**Mt Piper Power Station
Ash Placement Project 09_0186
Submissions Report
Response to Departmental & Agency Issues**

Response to SCA Letter dated 28 April 2011

MOUNT PIPER ASH PLACEMENT PROJECT - SUBMISSIONS REPORT APPLICATION NUMBER MP09_0186

Figure 8 – Distribution of Concentrations of Chloride (mg/L) in Groundwater 2000-2005 (from Merrick, 2007)

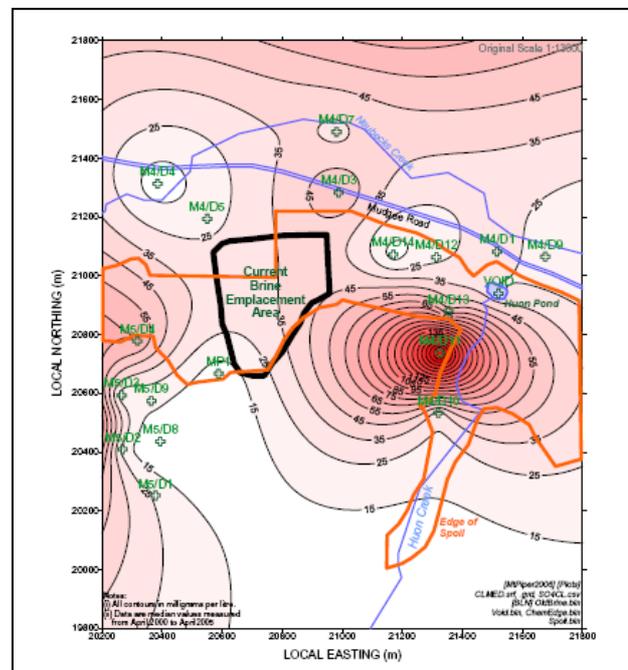
2. The SCA acknowledges that the increasing trends in chloride concentration in Neubecks Creek and the groundwater collection basin, located downstream of the ash placement site, are minimal and well within ANZECC guidelines and may be due to drought conditions. However, the SCA **is not satisfied** that the increase in chloride concentration is most probably due to the effects of upstream mining activities and not related to ash placement.

Delta: There is a naturally occurring salt deposit in the goaf mine area near bore D11, which has a high chloride concentration (Figure 8 from the 2007 model report by Merrick, 2007 is reproduced below for reference). The small increase in chloride in the GCB and Neubecks Creek was suspected to be due to damage to or removal of part of the coal barrier between the goaf mine area and the GCB. Update of the model in 2007 showed this was a feasible explanation. Groundwater flows are from bore D11 to the GCB and the model predicted the increase in chloride would be expected with an increase in flows due to changes to the coal barrier. This, together with the recent water level rise due to water conditioned ash placement (see Figure 9 in the Aurecon, 2009 report) is most likely introducing low levels of chloride from the goaf to the GCB.

Delta: As shown in Figure 8, above, naturally occurring salt deposits occur in the mining area, so chloride is not just an indicator of ash placement.
